**Report: Issue Data**  
**Function: Test, Adjust, & Balance**  
**Date: 02/05/2026**  
**Completed By: National TAB**

**PROJECT**  
**CW 9111 - OCC Expansion (Coppell, TX)**

## **Issue List**

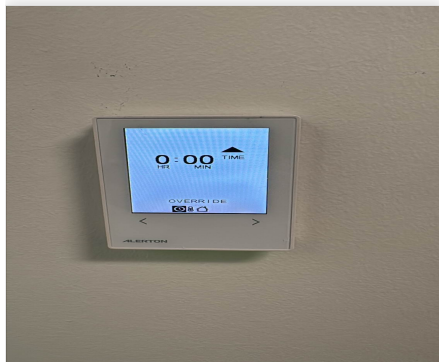
**Issue Name :** VAV5-3 NOT OPERATIONAL (VAV-2A-30 CONTROLS LABEL)  
**Description :** Unit is not operational. Unit is showing "NR" on controls graphics. Unit is wired for power and power switch is in ON position. Scrolling through thermostat options and it shows "No Custom Codes". This leads to believe this box has not been programmed. Box shows up on controls graphics matrix for the floor but not on the floor layout page.
